ISO/IEC
7776

AMENDMENT 1
1996-11-15

**Information technology —
Telecommunications and information
exchange between systems — High-level
data link control procedures — Description
of the X.25 LAPB-compatible DTE data link
procedures**

AMENDMENT 1: Modulo 32 768 and
multi-selective reject option

Table 11 – Control and Information field encoding of SREJ frame - modulo 32 768 operation

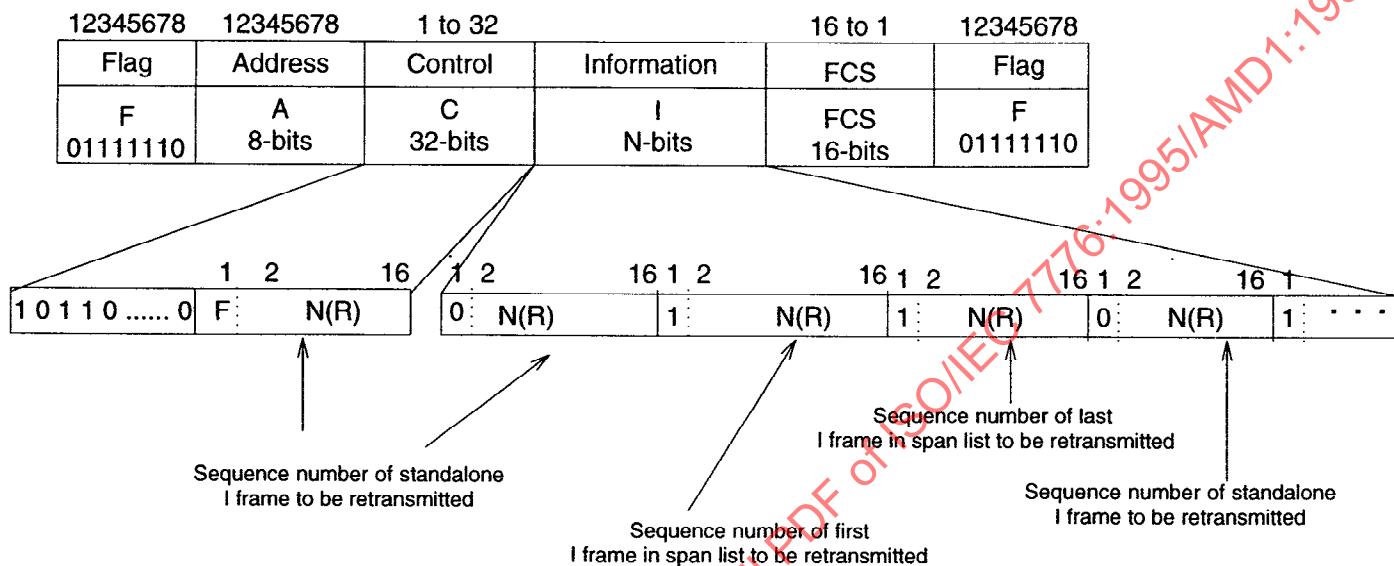
For modulo 32 768 operation, the information field shall be encoded such that there are two octets for each standalone I frame in need of retransmission, and a four-octet span list for each sequence of two or more contiguously numbered I frames in need of retransmission, as depicted in table 11. In the case of standalone I frames, the sequence number of each designated I frame shall occupy bit positions 2-16 of the two octet field, with bit position 1 set to zero, as depicted in table 11. In the case of span lists, the sequence number of the first designated I frame in need of retransmission is encoded in the first two octets (of the four octet field for span lists) and the second two octet field contains the sequence number of the last designated I frame in the sequence in need of retransmission. Sequence numbers in both two octet fields are encoded in bits 2-16 with the bit position 1 in both two-octet fields set to 1 as depicted in table 11.
